To: Mark Hargrove
From: Pat O'Mahony, Associate Planner; 910-341-0189
CC: File;
Date: 8/10/2020
Re: 6721 Market Street

The following is a list of comments for review from planning regarding the project. Please provide your corrections as listed below. A staff summary of comments:

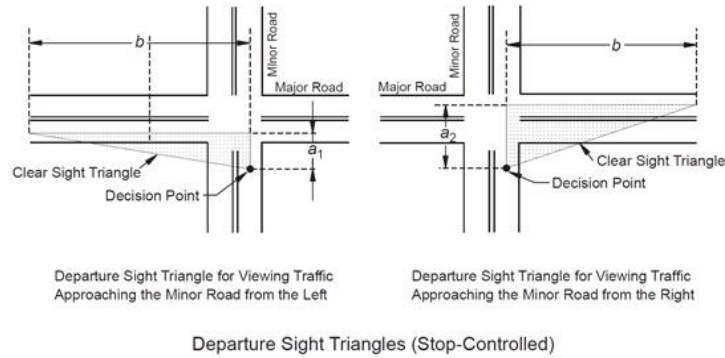
1. A stop sign and stop bar must be installed in advance of potential crosswalk and outside Market St ROW for the driveway accessing Market St.
2. **SIGHT DISTANCE TRIANGLE FOR ANY STREET/DRIVEWAY INTERSECTIONS WITH THOROUGHFARES**

Market St is a major thoroughfare [Chap VII (C) (2) (a) of CofW Tech Stds]. In accordance with the City Code, sight distances along thoroughfares must be calculated in compliance with the AASHTO requirements. [Chap VII (C) (1) of CofW Tech Stds] [Sec. 18-556 CofW LDC]. Show AASHTO SDT in addition to 20'x70' SDT for driveway on site and planting plans.

Provide the dimensions a1 & a2 from the decision point as per below image on site and landscape plans. Show the AASHTO triangles for landscape plan also.
